M.I. 9650
*Rev. A

MAINTENANCE INSTRUCTION

MODERNIZATION RECOMMENDATION DYNAMIC BRAKE GRID PROTECTION

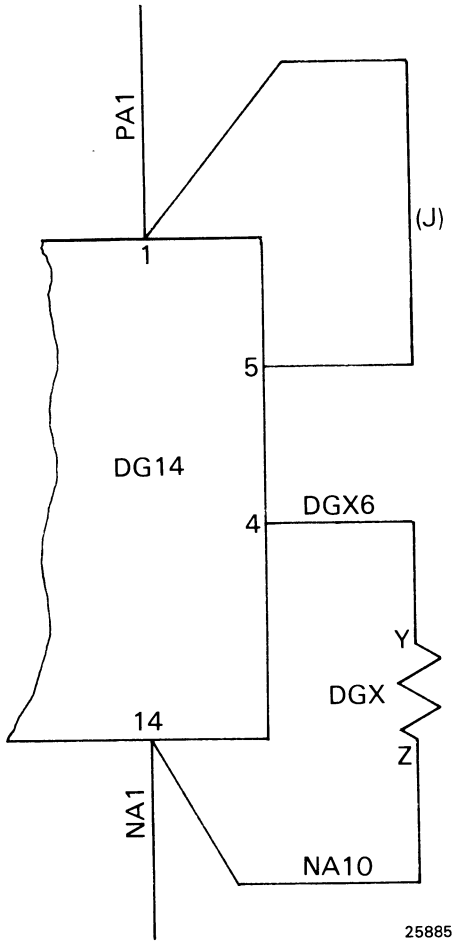
1. Select a convenient location in the high voltage cabinet; mount and label DGX relay.
2. Mount the DG14 panel assembly on the contactor mounting channel located in the lower half of the high voltage cabinet.
3. Refer to Fig. 1 and add the following XE wires:

<u>TAG</u>	<u>FROM</u>	<u>TO</u>
BB34	*RE Grid 3 - Term 1	TB38L8
BB33	TB 38L8	DG-7
BM14	*RE Grid 3 - Term 4	TB38L9
BM13	TB38L9	DG-8
BKG14	*RE Grid 3 - Term 2	TB38L10
BKG13	TB38L10	DG-9
BKE24	*RE Grid 4 - Term 2	TB38R10
BKE23	TB38R10	DG-11
BM24	*RE Grid 4 - Term 4	TB38R9
BM23	TB38R9	DG-12
BR44	*RE Grid 4 - Term 1	TB38R8
BR43	TB38R8	DG-10

Fig.2 - Modified Module Control Circuit

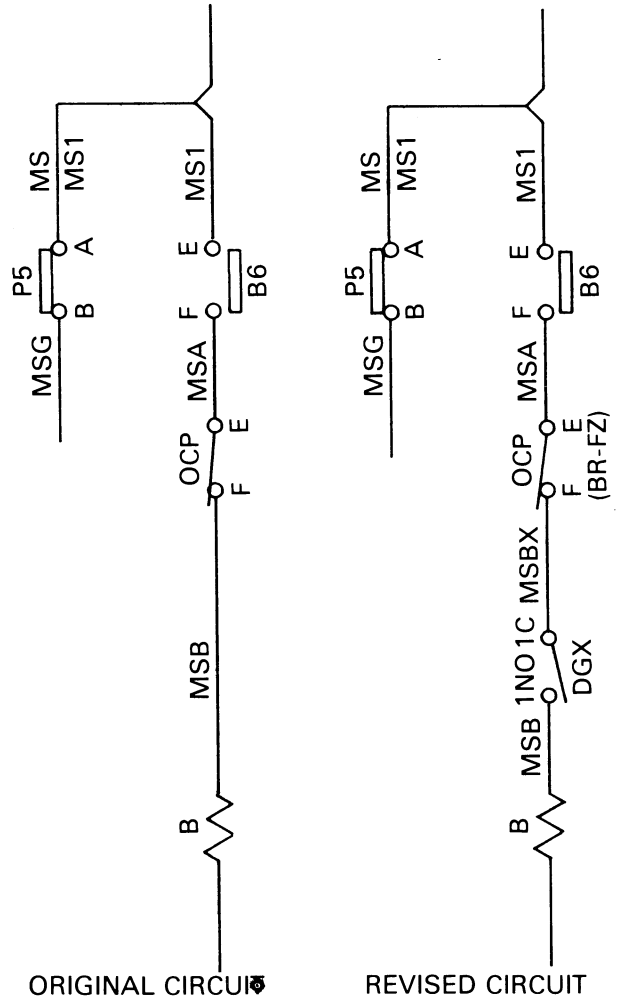
4. Refer to Fig. 2 and add the following No. 14 wires:

<u>TAG</u>	<u>FROM</u>	<u>TO</u>
PA1	DG-1	TB30R1
J	DG-1	DG-5
NA1	DG-14	TB30L2
NA10	DG-14	DGX-Z/Coil
DGX6	DG-4	DGX-Y/Coil

Fig.3 - Control Circuitry, Step 5a.

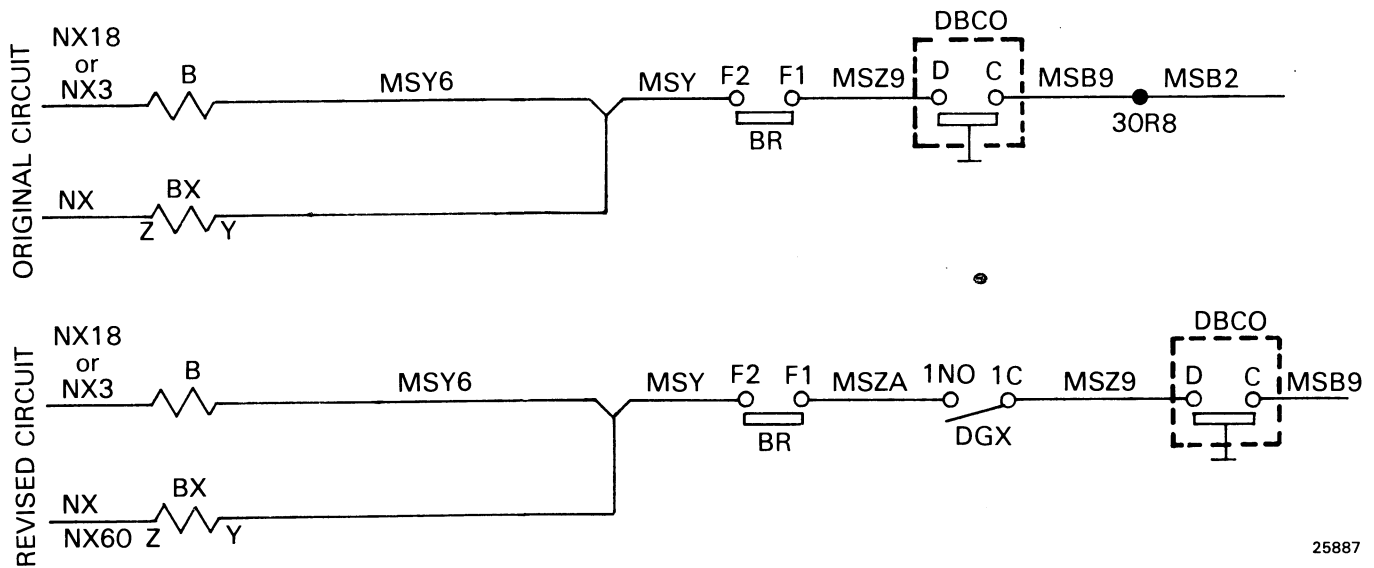
5. Step a. refers to units with a circuit similar to that indicated in Fig. 3.

- a.
 1. Move MSB wire from OCP-F to DGX-1NO.
 2. Add a new No. 14 wire from OCP-F to DGX-1C and label as MSBX.
- b.
 1. Move MSZ9 wire from BR-F1 to DGX-1C.
 2. Add a new No. 14 wire from BR-F1 to DGX-1NO and label as MZZA.

**Fig.5 - DGX Relay Interlocks, Units Equipped
With Self Load Test**

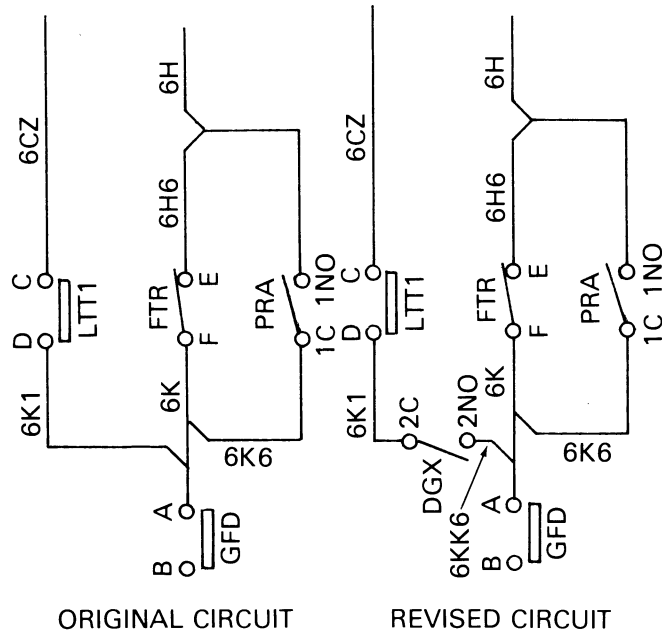
6. On units equipped with self load test make the following additional changes; refer to Fig. 5.
 - a. Move 6K1 wire from GFD-A to DGX-2C.
 - b. Add a new No. 14 wire from DGX-2NO to GFD-A and label as 6KK6.
